PROJECT/SITE OWNER:	PROJECT SUMMARY:
Bayside Development Partners II, LLC	New mixed occupancy 5 story building
PROJECT ADDRESS: 600 Block of West Glencoe Place

**Re:** **Building C – Architectural Review Committee Submittal**

# ONE NORTH - MULTIFAMILY BUILDING C

VILLAGE OF BAYSIDE ARC REVIEW

# SITE SIGNAGE PLAN

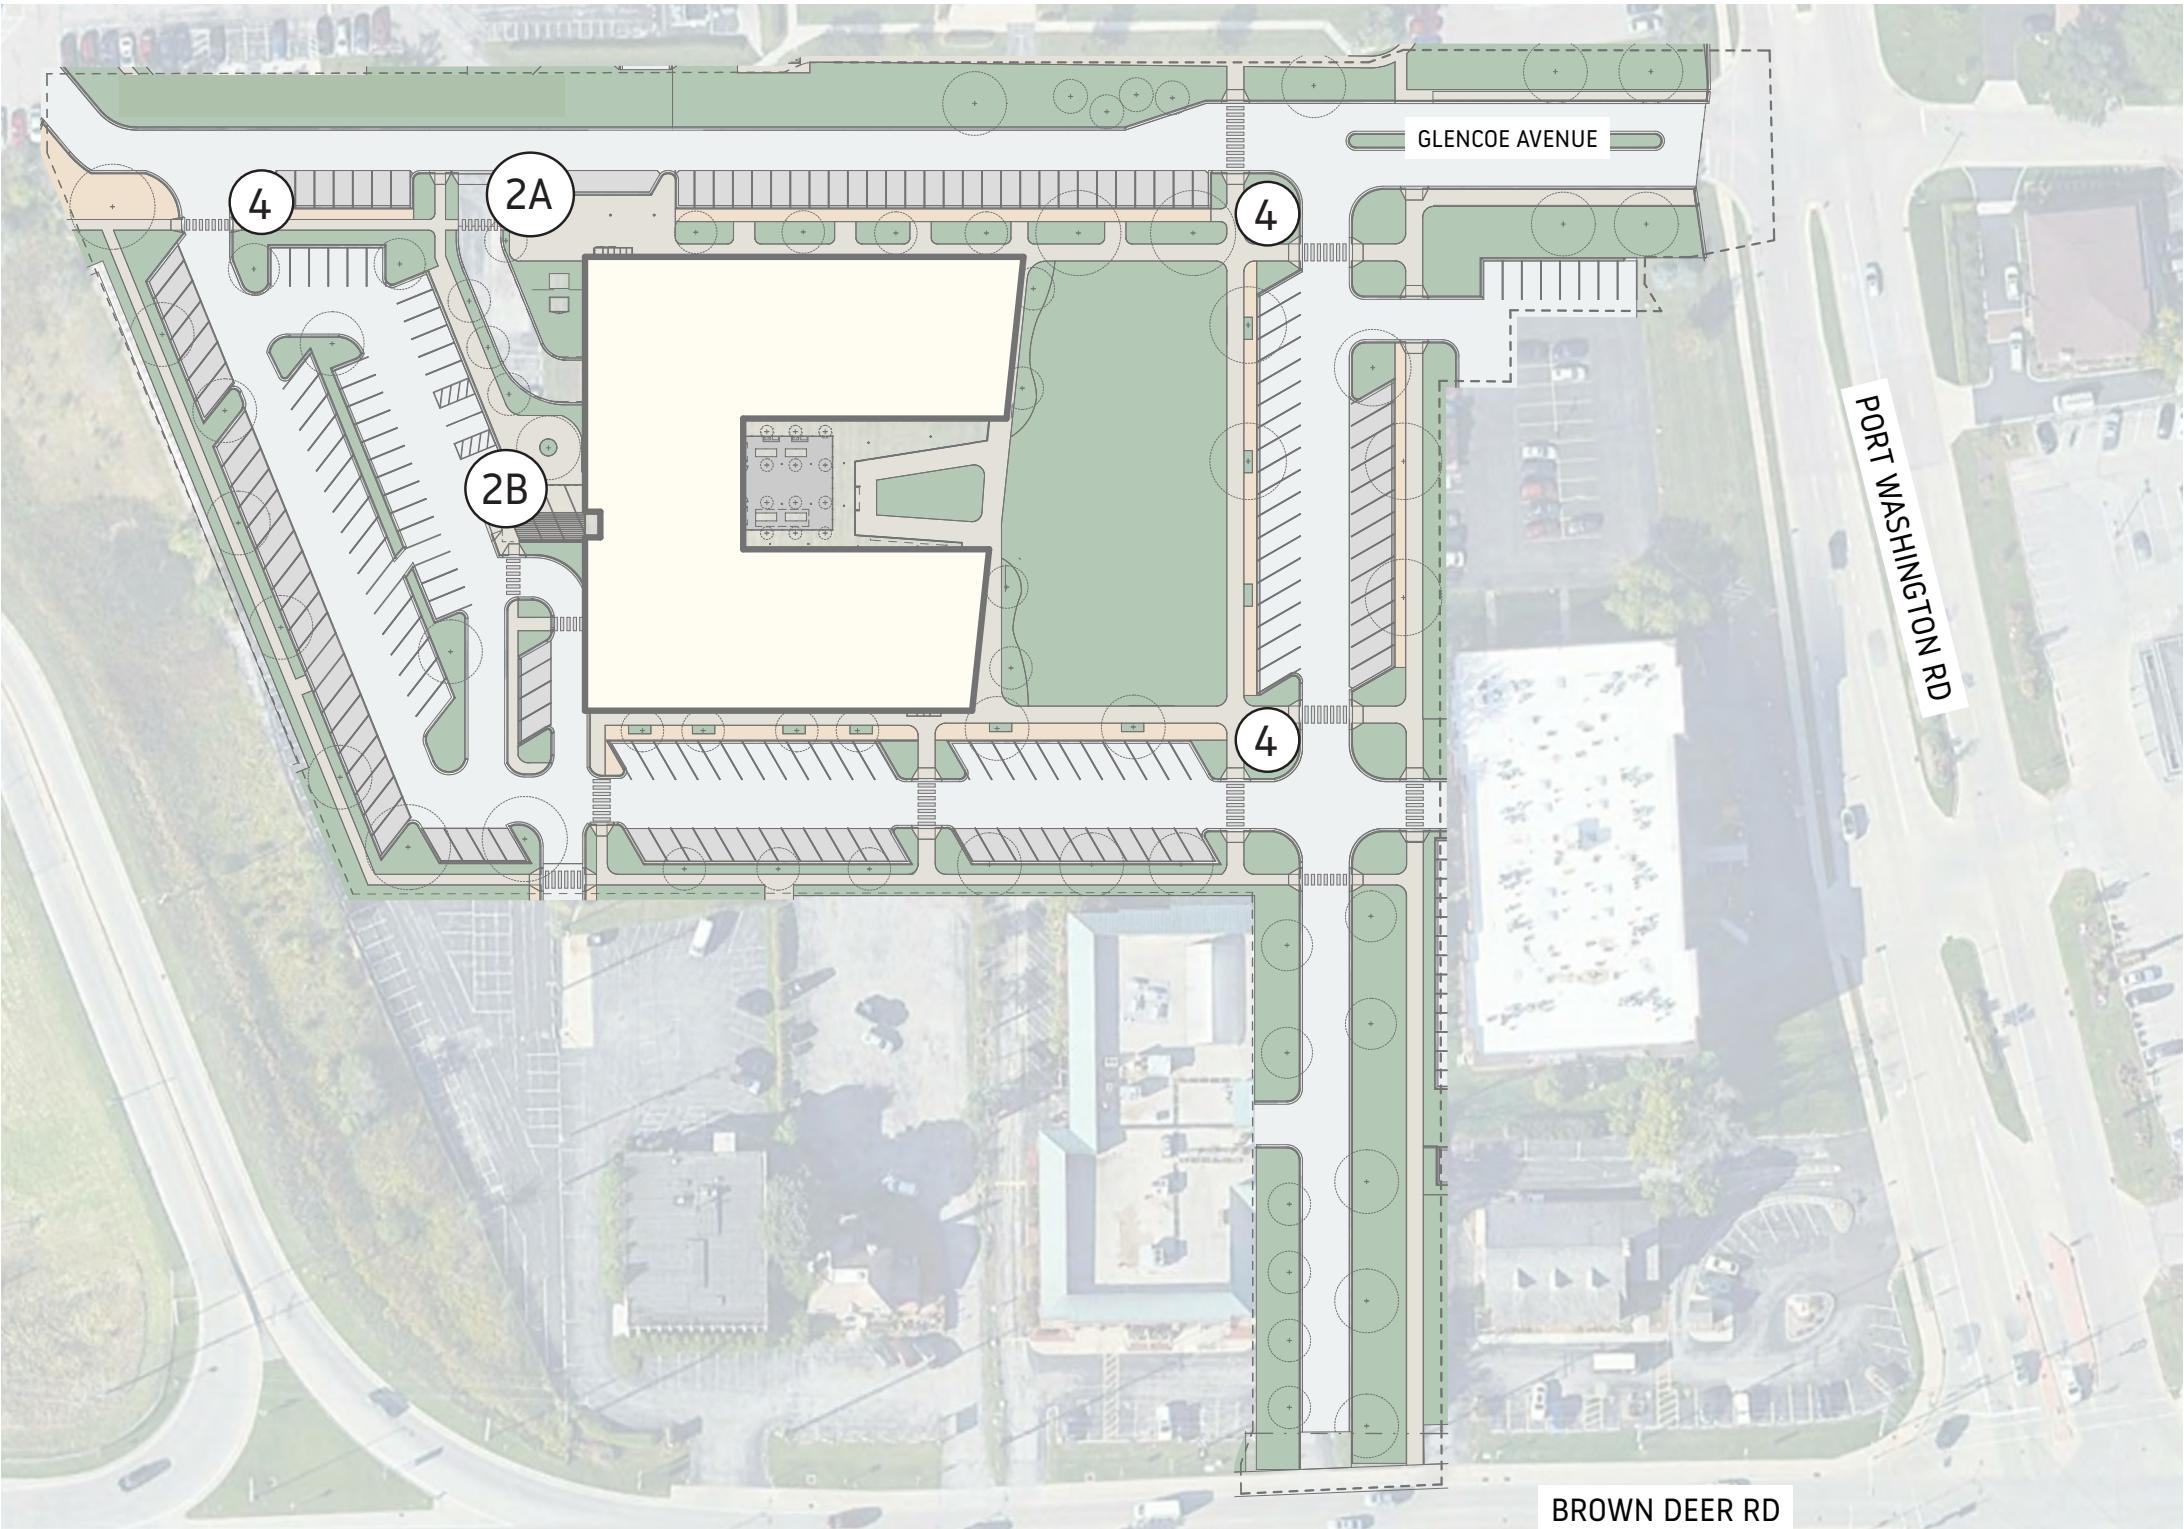
The submitted “Site Signage Plan” identifies two ground monument signs. The first, located along the proposed Glencoe Avenue will be double sided, a maximum of four feet in height, and a maximum of 24 square feet in area on each side. The second, located at the library entrance ion the west side of the building, will be double sided, a maximum of six feet in height, and a maximum of 48 square feet in area on each side. Pedestrian-oriented wayfinding signage is proposed at the northwest, northeast, and southeast corners of the site. These will be double-sided and limited four feet in height and eight square feet in area. The proposed site signage is appropriate given the size of the building and surrounding context.

# SIGNAGE ELEVATIONS

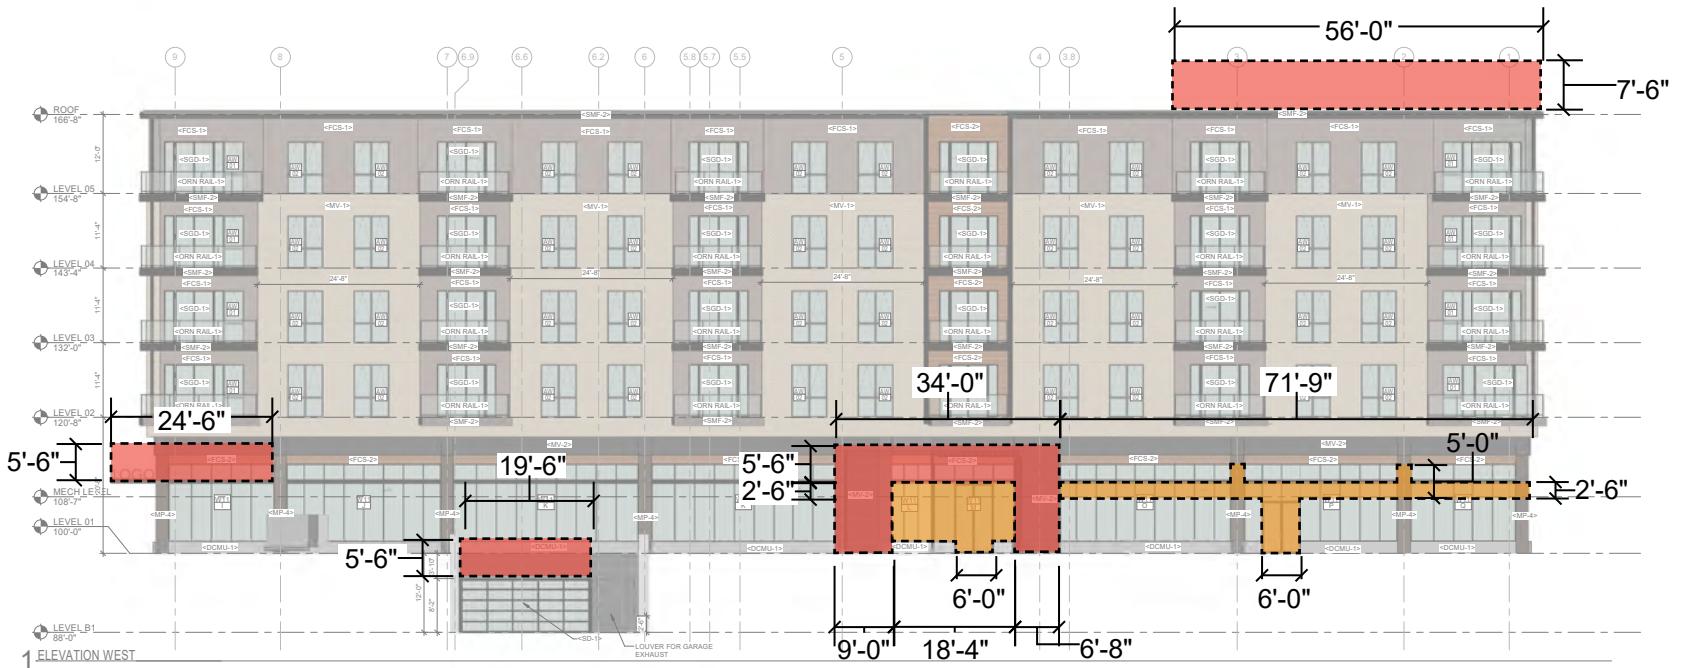
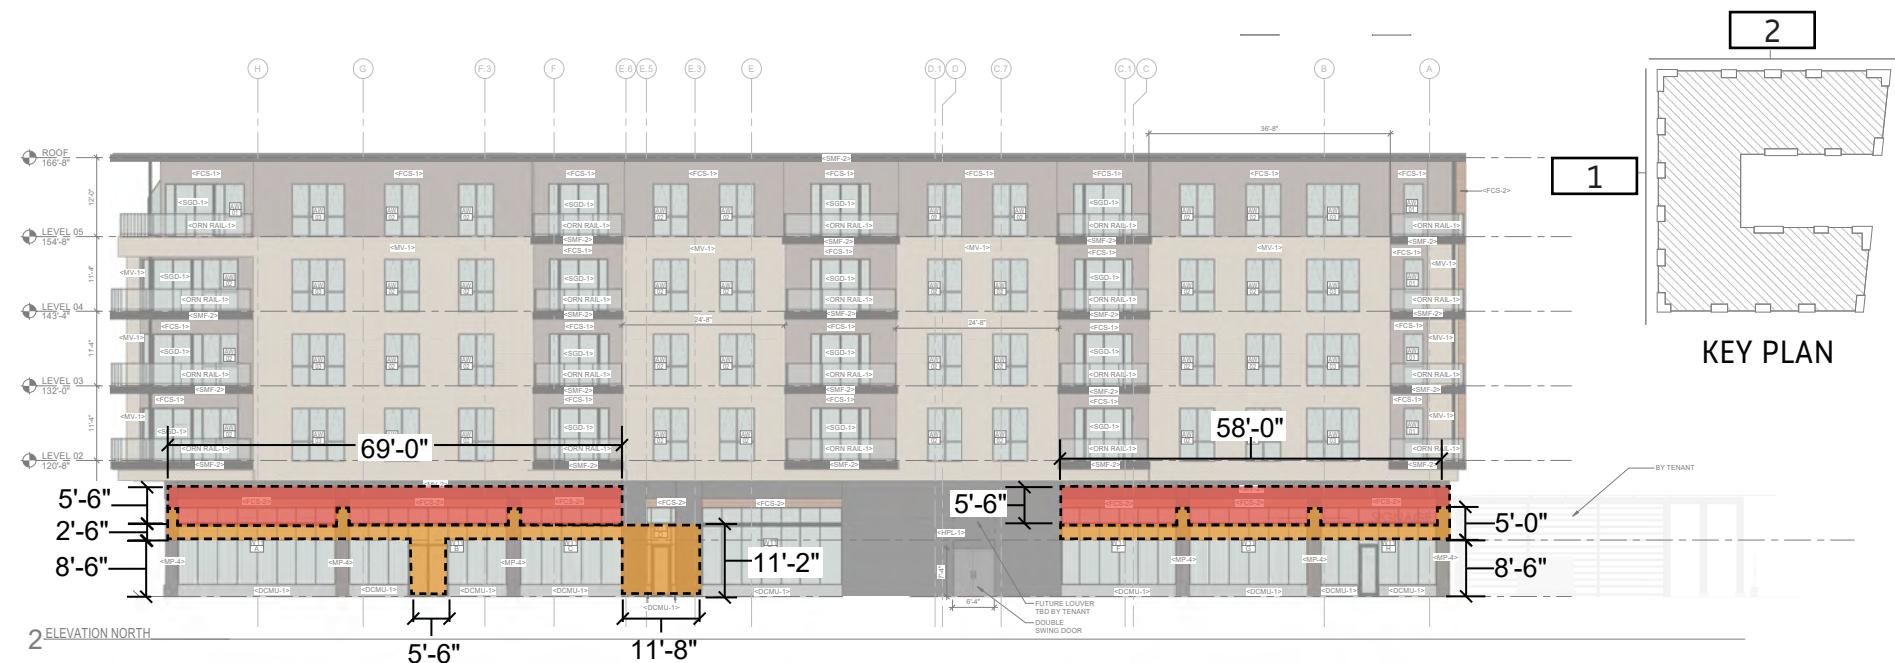
As for on-building signage, the submitted “Signage Elevations” identify primary and secondary signage zones on the first floor. Major entry tenant signs are to be limited to one column bay width per side. Sign permits will be reviewed and approved by the Village as tenants are finalized.

4. Add bicycle parking for at least 20 bicycles for library patrons and customers of the first floor uses.
5. Submit applications for sign permits for review and approval as tenants are finalized.

Sheet:  
**OVERALL SITE  
LANDSCAPE PLAN**

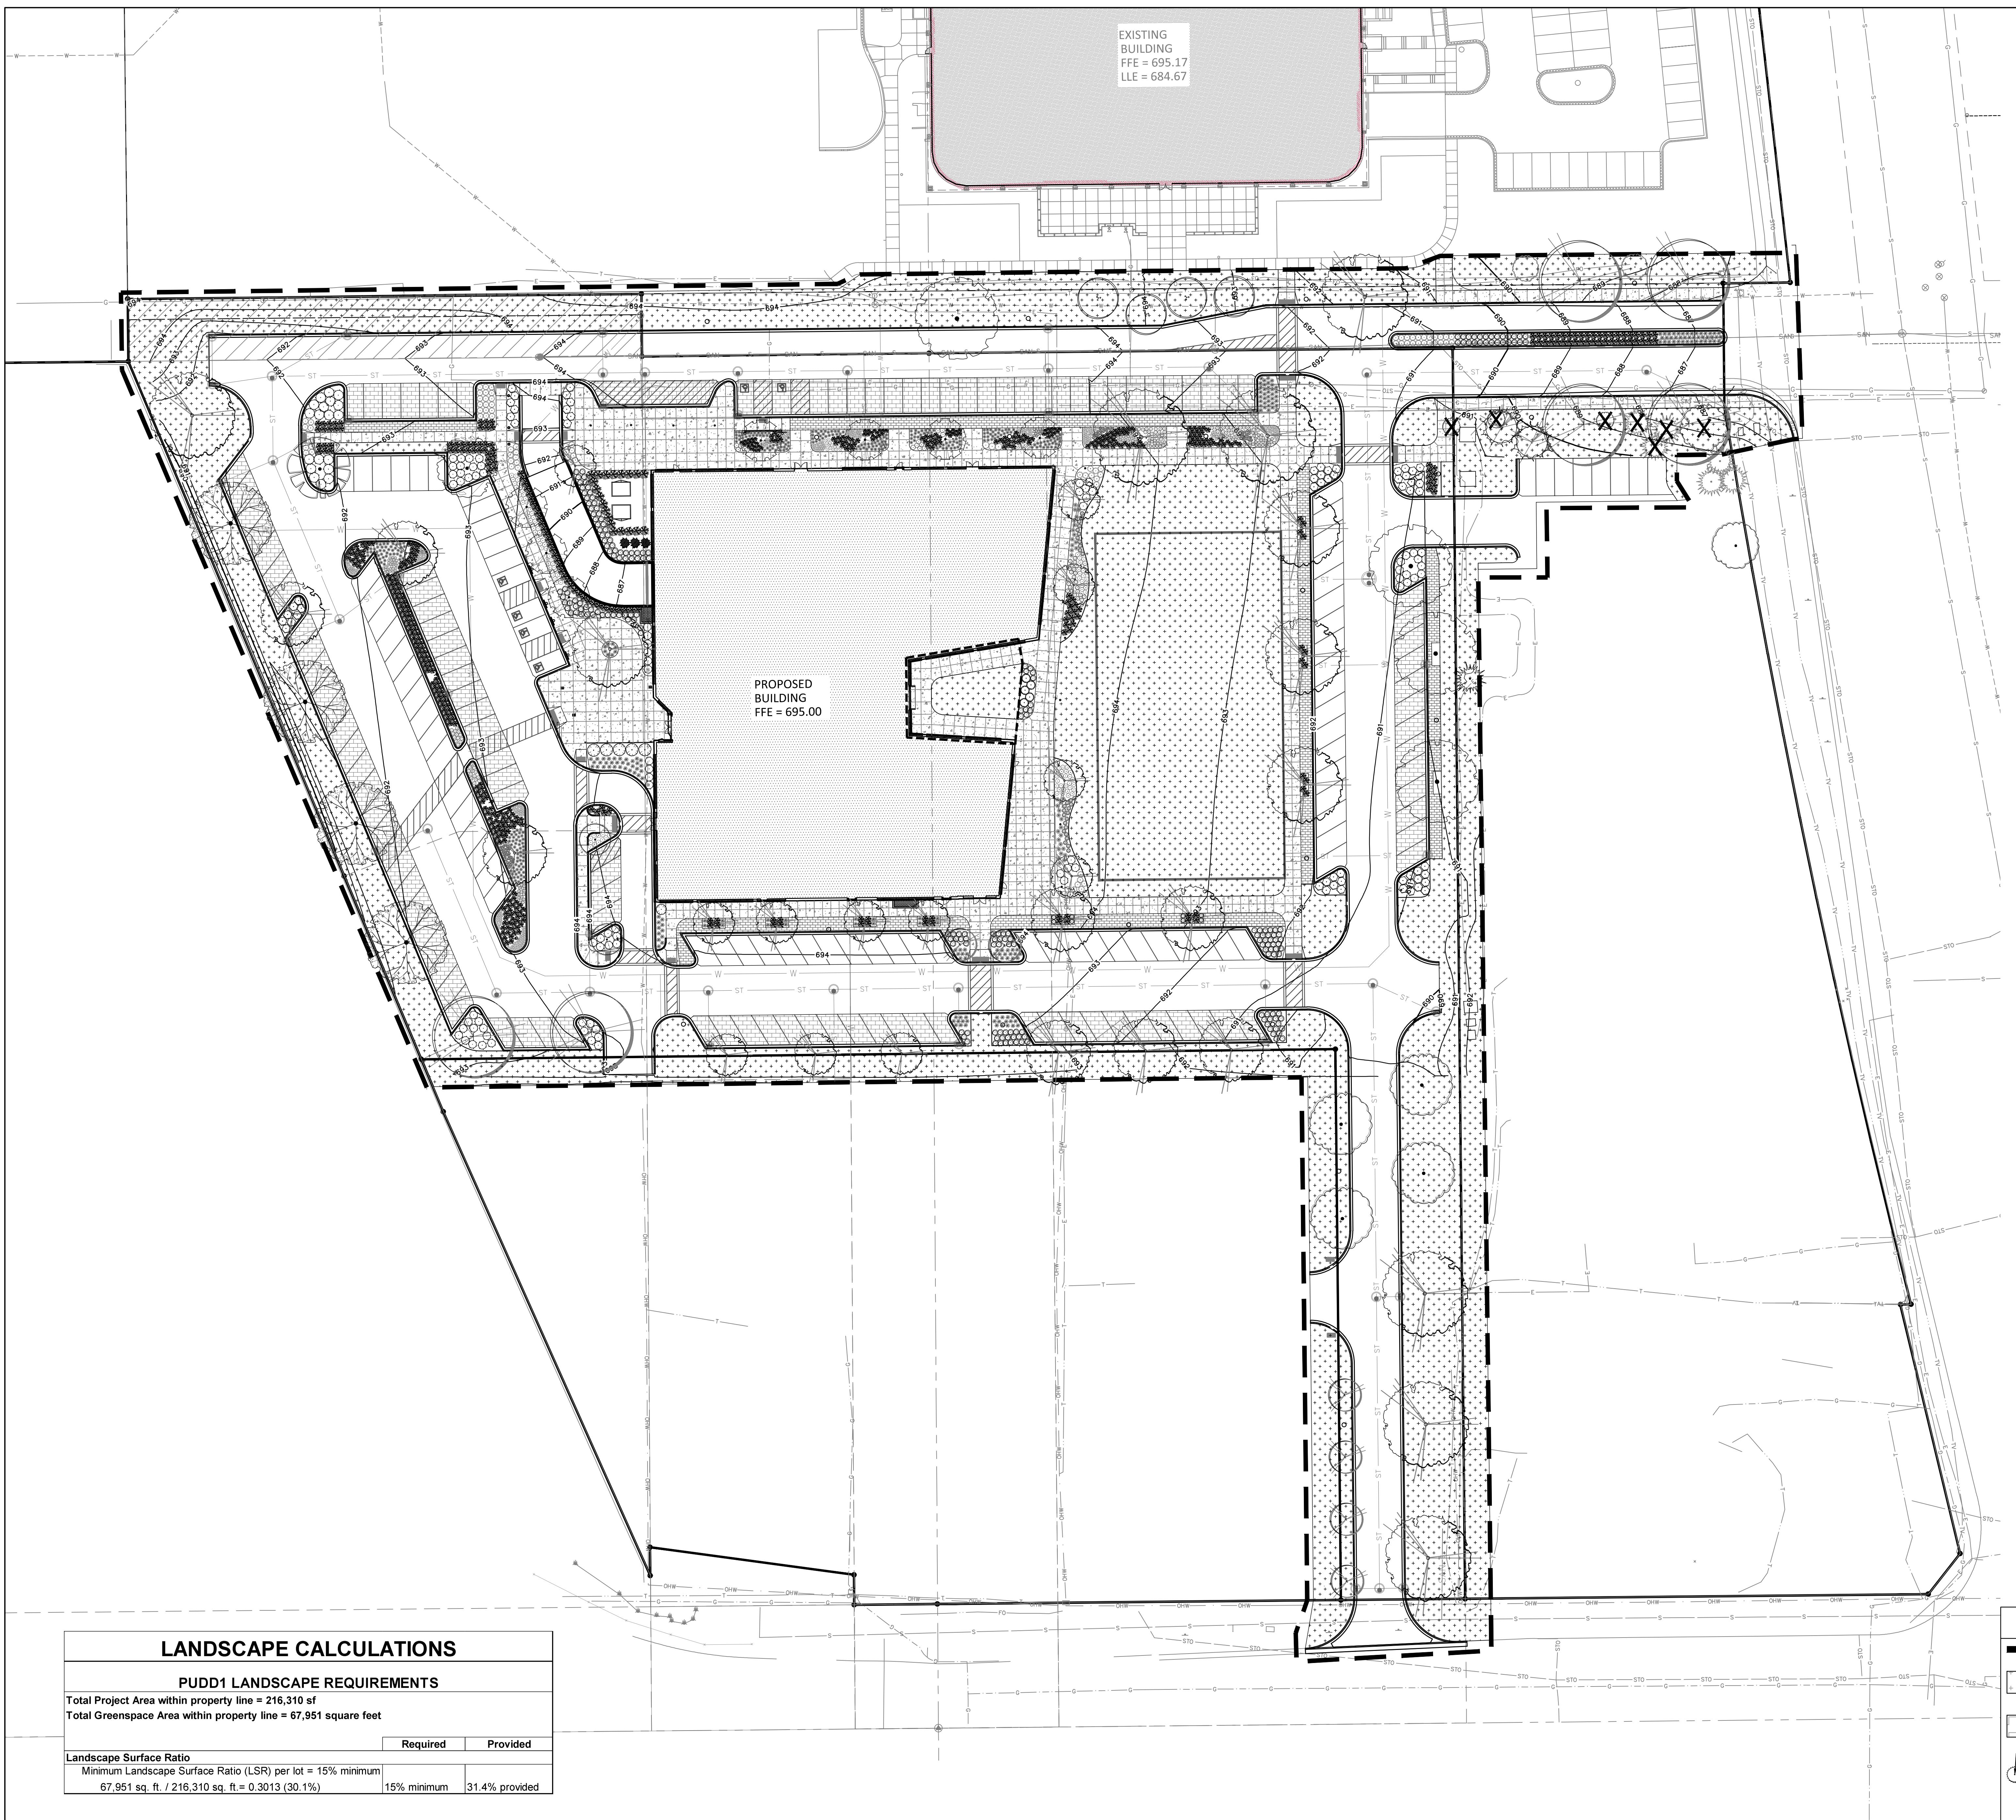
Plants located on the north side of building will generally be shaded by the five-story building, which affects selection of plant species. Vandewalle staff offers the following notes on plantings located on the north side of the building:

- Quaking Aspen needs four hours of direct sunlight daily. If not provided, consider a more shade-tolerant species.
- Morning Star Sedge prefers direct sunlight. May not grow successfully in shade.
- Black Eye Susan prefers direct sunlight. May not grow successfully or flower in shade.
- Cream and Blue False Indigo may not flower in shade.
- Tufted Hair Grass may not flower/seed in shade.
- Sky Blue and New England Aster may flop in shade.
- Blue Sage prefers some direct sun daily.

A final note is that “Native Mix 1” is noted in the legend but not shown on the plan.

6. Use shade-tolerant plant species on the north side of the building, as described on page 4 of this report.
7. Add a canopy over the library entry area and drive-through window.
